Appl. No. 09/667,596
2658-0190P
Page 17

REMARKS

Applicant:	In Duk SONG et al.	Conf.:
Appl. No.:	09/667,596	Group: 2871
Filed:	September 22, 2000	Examiner: H. Nguyen
For:	THIN FILM TRANSISTOR SUBSTRATE OF LIQUID CRYSTAL DISPLAY AND METHOD OF MANUFACTURE

DRAWING CORRECTION AUTHORIZATION REQUEST

FIG.2

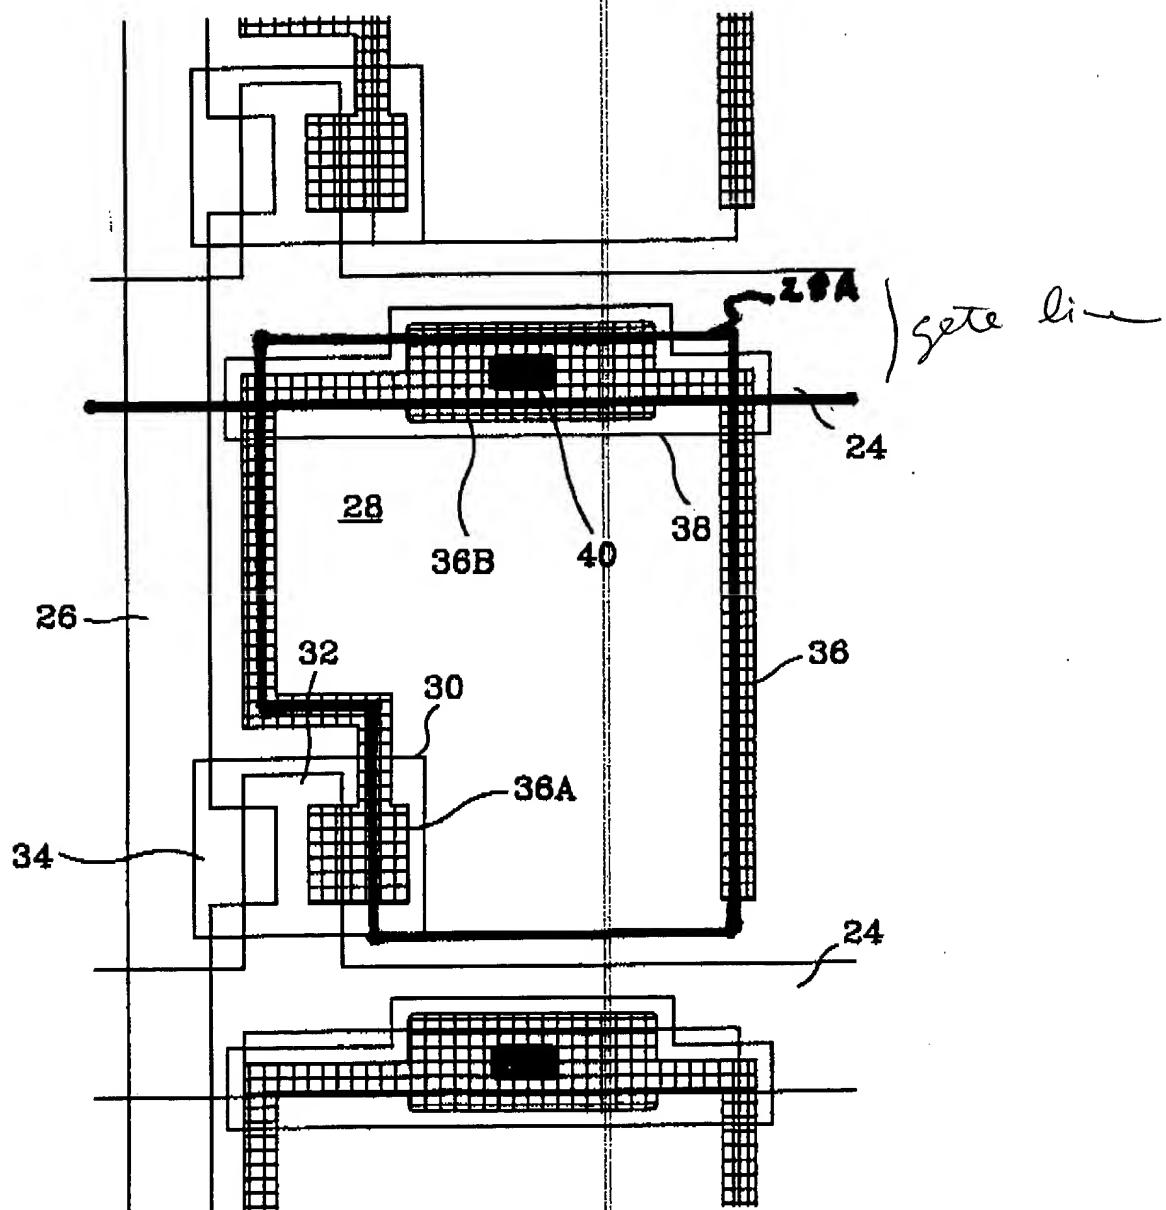
The Examiner objected to the drawings requiring that the recited feature of claim 18, "the pixel electrode overlaps a gate lines less than if the protective layer included a contact hole over a storage electrode part of the metallic pattern" must be shown or canceled from the claim.

Applicant conducted a telephonic interview with the Examiner on March 4, 2002 to discuss the drawings relative to this claimed feature. The Examiner acknowledged that the claimed feature is shown in the drawing, but stated that the feature is not shown with sufficient clarity. Applicant agreed to submit a Drawing Correction Authorization Request (DCAR), proposing changes to the drawings to identify the boundaries of the pixel electrode in a manner such that the extent of overlap/non-overlap of the gate lines is readily apparent. A DCAR is submitted herewith. Applicant has designated the overlapping edge of the pixel electrode as 28A in Figures 2 and 3 and amended to specification accordingly. Withdrawal of the objection is respectfully requested.

Applicant submits that the thin film transistor, identified by reference numeral 30, is shown in the drawing. The TFT consists of source, drain and gate electrodes meeting the requirement for definition as a transistor. For example, figure 2 shows a thin film transistor (TFT) that includes a source electrode (34) protruding from data line (26). The TFT has a gate electrode (32) protruding from gate line (24), and a drain electrode (36A). The drain electrode is part of the same continuous pattern as storage electrode part (36B).

In rejecting claim 28, the Examiner asserts that the claim language, as recited, renders the device as non-functional in that there is no connection between the pixel electrode and the drain electrode. Using Figure 2 as an example, Applicants request that the Examiner note that the protective layer does not have a contact hole exposing the drain electrode part (36A) of the metallic pattern. This however, does not preclude connection between the pixel electrode and the drain electrode. The reason is that the protective layer forms one continuous layer that also includes the storage electrode part, and the drain electrode part is connected to the pixel electrode at contact hole 40 at the storage electrode part.

Subject to the approval of the Examiner, Figs. 2 and 3 will be amended to as indicated in red on the attached photocopies thereof.

In particular, reference numeral 28A and its associated lead line will be added to Figs. 2 and 3, and the boundaries of the pixel electrode will be clarified such that the extend of overlap/non-overlap of the gate lines is readily apparent.

It is respectfully requested that these proposed drawing corrections be approved and that all drawing objections be withdrawn.
